Access Compliance Report Public Rights-of-Way (Curb Ramps)

Intersection ID: 14299 Main Street: N_I-77_EXIT_8_RA Cross Street: REMOUNT_RD Location: S

ADA ID: 31D869FAF20E Ramp Type: Perp Initial Pass/Fail: Fail Overall Compliance: No Severity Score: 13.75

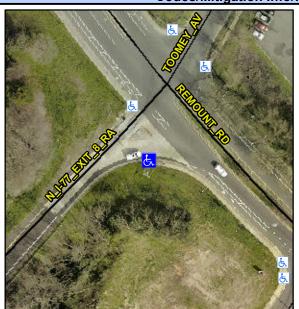
Not Found, R304.2.2, R304.5.3

Field Measurements/Component Compliance					
Compliance Description		Data	Comp	liance Description	Data
N/A	Ramp Length (in)	56.0	No	Ramp Slope (%)	9.1
Yes	Ramp Width (in)	48.0	No	Ramp XSlope (%)	3.6
N/A	Flare Type LT	N/A	N/A	Flare Type RT	N/A
N/A	Flare Slope LT (%)	N/A	N/A	Flare Slope RT (%)	N/A
N/A	Flare Traversable LT?	N/A	N/A	Flare Traversable RT?	N/A
N/A	Landing Length (in)	N/A	N/A	DWS Provided?	N/A
N/A	Landing Width (in)	N/A	N/A	DWS Contrast?	N/A
N/A	Landing Slope (%)	N/A	N/A	DWS Length (in)	N/A
N/A	Landing X Slope (%)	N/A	N/A	DWS Full Width?	N/A
N/A	Landing Curb? (Y/N)	N/A	N/A	DWS Offset (in)	N/A
N/A	Shared Landing?	N/A			
N/A	Gutter Ponding?	N/A	N/A	Gutter Slope (%)	N/A
N/A	Gutter Lip Ht (in)	N/A	N/A	Gutter X Slope (%)	N/A
N/A	Painted X Walk1?	No	N/A	Painted X Walk2?	N/A
	X Walk 1 Direction	To NW		X Walk 2 Direction	N/A
N/A	X Walk 1 Width (in)	N/A	N/A	X Walk 2 Width (in)	N/A
	X Walk 1 Slope (%)	4.8		X Walk 2 Slope (%)	N/A

Remove & Replace Entire Ramp.
